August 2025
Design Development Updates

Upper Brook Street Masterplan (McLaren / Kadans)

UBS-SRA-XX-XX-RP-A-00101

This document has been produced by Sheppard Robson and proposes minor changes to the approved Sci-Tech scheme located in Upper Brook Street, Manchester.

Cross Section
Consented

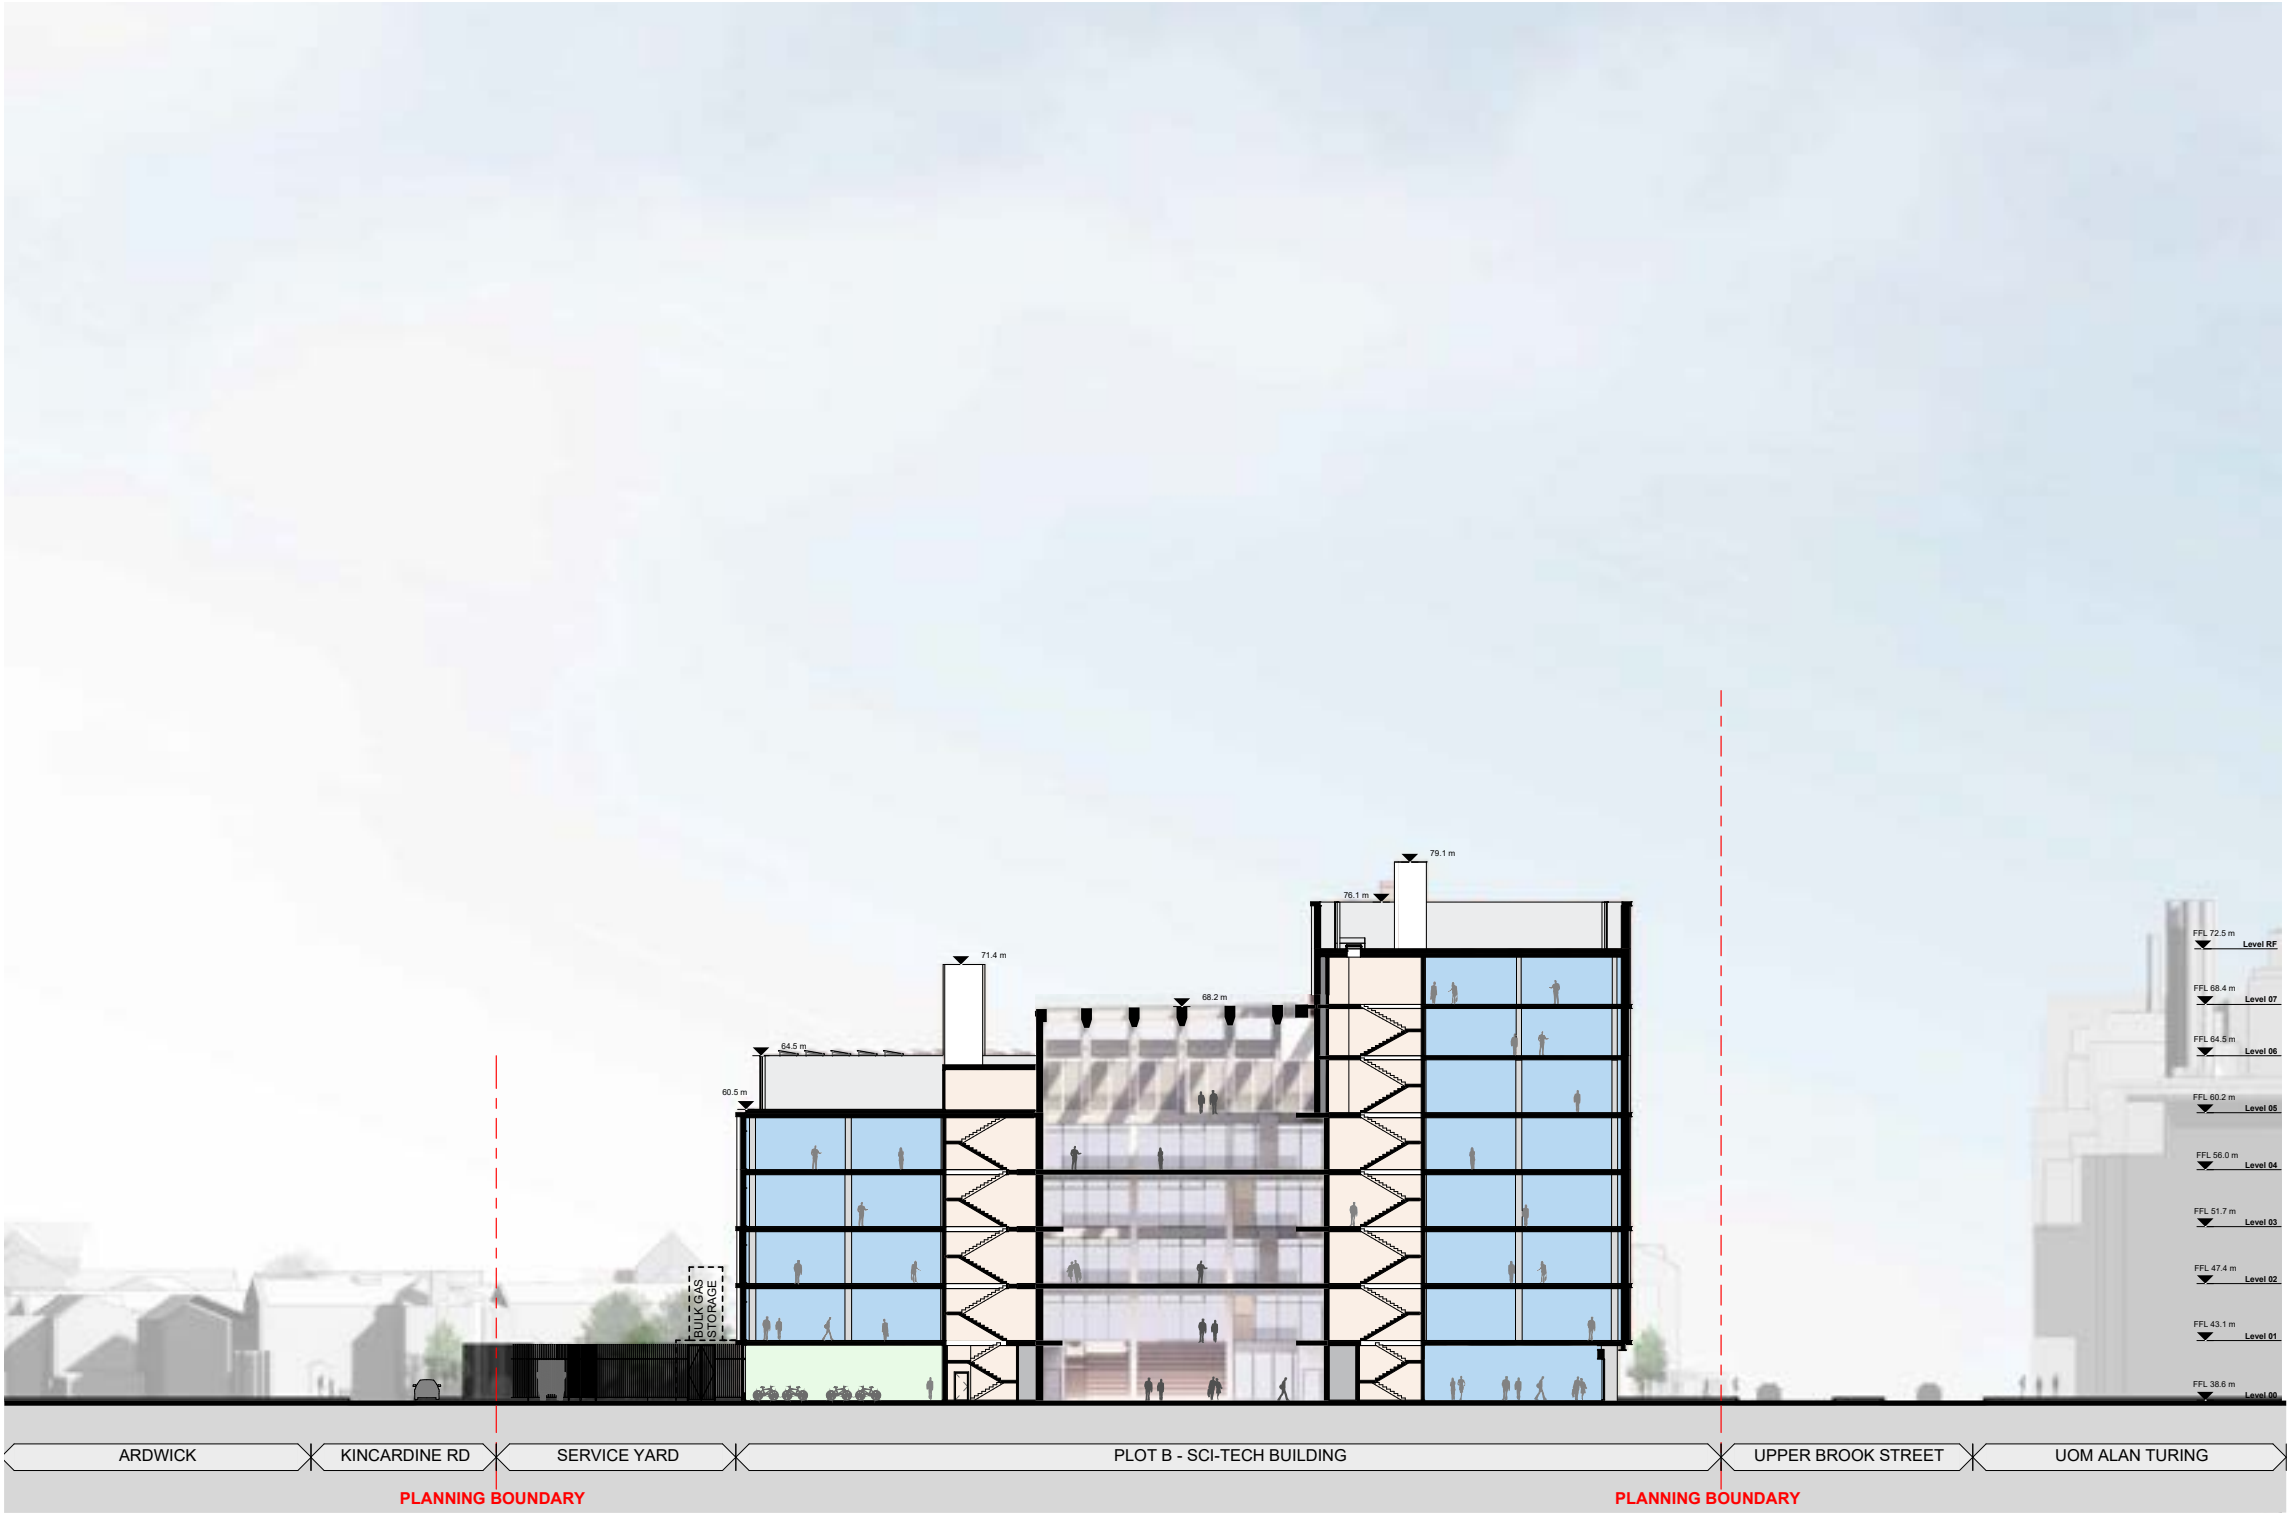
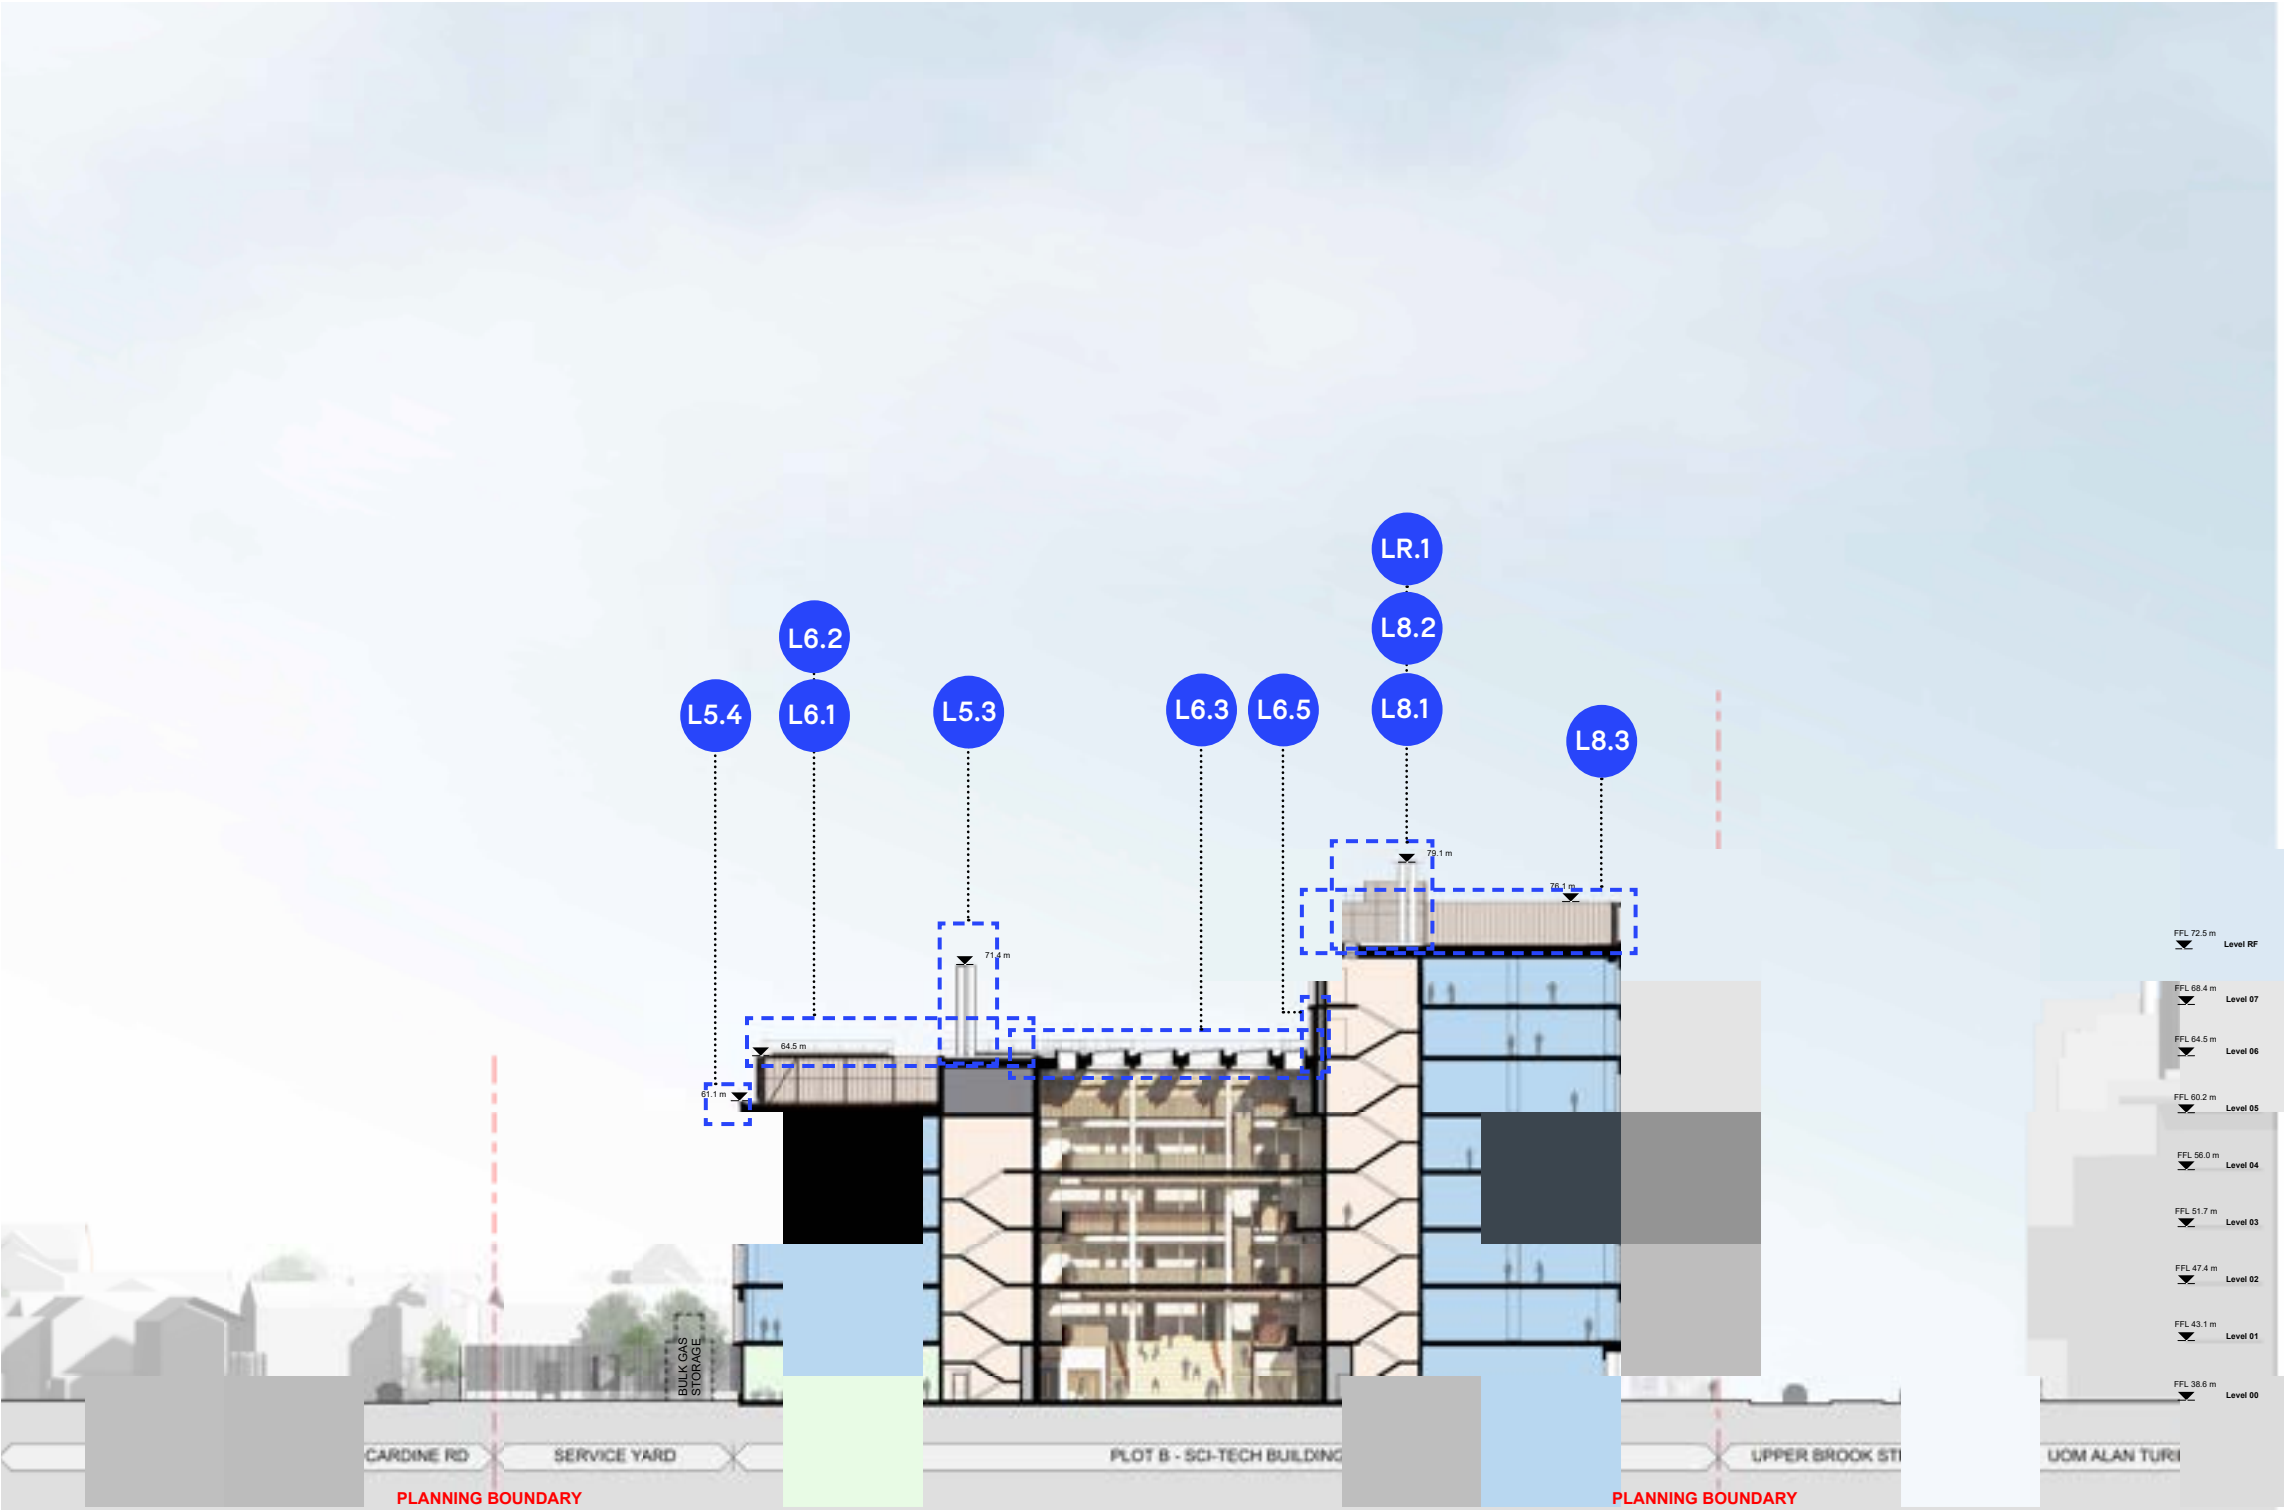
- L5.3

The future tenant flue zone was clarified, and flues have been included for illustrative purposes.
- L5.4

The Level 05 parapet detail was developed.
- L6.1

The PV layout and the platform extent was optimised.
- L6.2

A safety perimeter guardrail was added to the PV platforms.
- L6.3

The Atrium roof was lowered one level, from Level 07 to Level 06. Changes to the Atrium roof design.
- L6.5

The piers directly above the atrium roof are to be flattened to allow for the minimum maintenance clearance.
- L8.1

The core overrun footprint was slightly increased following cladding and structure coordination.
- L8.2

The future tenant flue zone was clarified, and flues have been included for illustrative purposes.
- L8.3

The plant screen location in the Level 08 roof was moved outwards to reduce the distance to the facade piers.
- LR.1

Core overrun safety perimeter guardrail added

Change Code	Drawings Affected	Description	Design Development Justification
L5.3	Refer to page 22	Future tenant flue zone clarified	Following building services coordination, flue design and zone has been clarified, flues have been included for illustrative purposes.
L5.4	Refer to page 22	Level 05 parapet detail was developed.	Following facade development, the parapet detail was developed.
L6.1, L6.2	Refer to page 28	PV Layout and platform rearranged. Safety perimeter guardrail added.	PV Layout arrangement and platform design updated following MEP design development. A safety guardrail has been added around the PV platform for health and safety reasons following access and maintenance specialist advice.
L6.3	Refer to page 28	The Atrium roof lowered by one level with changes to the Atrium roof design.	The atrium roof was lowered and developed through a series of workshops with specialists
L6.5	Refer to page 28	Facade piers directly above the atrium roof flattened	This change has been developed to allow for the minimum maintenance clearance to the AOVs.

L8.1	Refer to page 34	Core overrun extent increased	Core overrun extent reviewed following cladding design development
L8.2	Refer to page 34	Future tenant flue zone clarified	Following building services coordination, flue design and zone has been clarified, flues have been included for illustrative purposes.
L8.3	Refer to page 34	Plant screen location moved outwards	Allows for more MEP roof space
LR.1	Refer to page 40	Core overrun roof perimeter safety guardrail added	Core overrun safety perimeter guardrail added to access and maintain ventilation equipment on top of core overrun
